NOTICE OF PROPOSED CHANGE IN PROPERTY

Petition: x1458

PETITION NO. 1458
 HUNTINGTON BANK
 37 W. BROAD ST.
 COLUMBUS, OH. 43137
 C/O JEFF STOGNER
 PHONE NO. 614 480-5020

REQUEST TO CONVERT TO EASEMENT
 THE EAST/WEST AND NORTH/SOUTH
 PUBLIC ALLEYS VARIOUS WIDTHS
 IN THE BLOCK BOUND BY
 MACK, WAYBURN, GOETHE AVE.
 AND ALTER RD.

CITY OF DETROIT
 CITY ENGINEERING DEPARTMENT
 SURVEY BUREAU
 JOB NO. 01-01
 DRWG. NO. X 1458

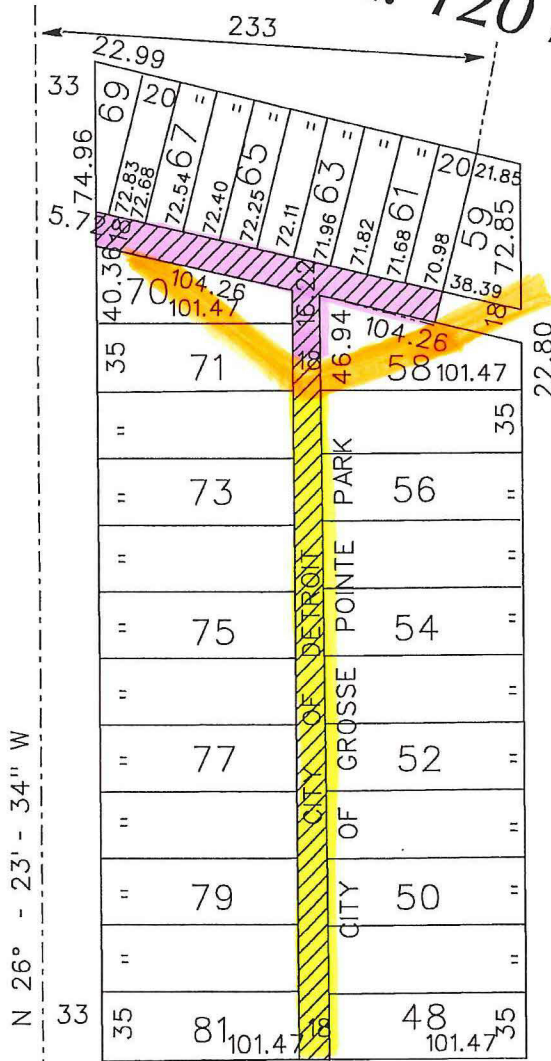
- Not Involved
- Involved; but asking you to hold action on this petition until further notice.
- Involved; but no objections to the property change.
- Involved; objection to the property change.
Please see attached sketch. A new easement will be required for overhead relocation with a cost of \$59,167.83.
- Involved; but no objections to the property change...provided as easement of the full width of the public right-of-way (street, alley or other public place) is reserved.
- Involved; the nature of our services and the estimated costs of removing and/or rerouting such services are:

vacation to easement
 will not be granted

new easement
 required for
 OH relocation.
 10' easement
 around new
 OH run.

* Please send revised petition reflecting changes *

To be vacated to easement
 once relocation cost has
 been paid in full. The
 cost to relocate facilities
 is \$59,167.83.
